## First Revision No. 600-NFPA 1900-2021 [ Global Input ]

## First Revision No. 121-NFPA 1900-2021 [ New Section after 4.1.3.2 ]

**First Revision No. 143-NFPA 1900-2021 [ Section No. 4.2.1.2 ]**

#### Figure 6.3.40.3 J Turn Track Dimensions.

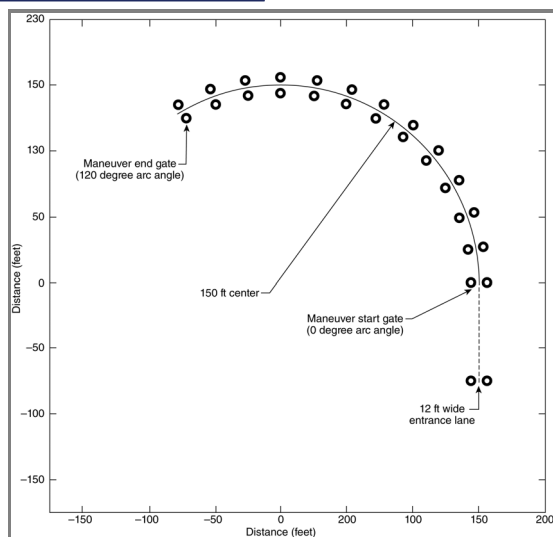
The J Turn track dimensions shall meet the dimensions shown in [Figure 6.3.40.3](#) .

**Committee Statement:** The committee is adding a test procedure for the j-turn as one currently does not exist in the document. Since there is no j-turn procedure, there are various methods that are used in the industry to complete this test. Adding a test procedure will ensure all vehicles are tested the same and provide consistency in the testing procedure.
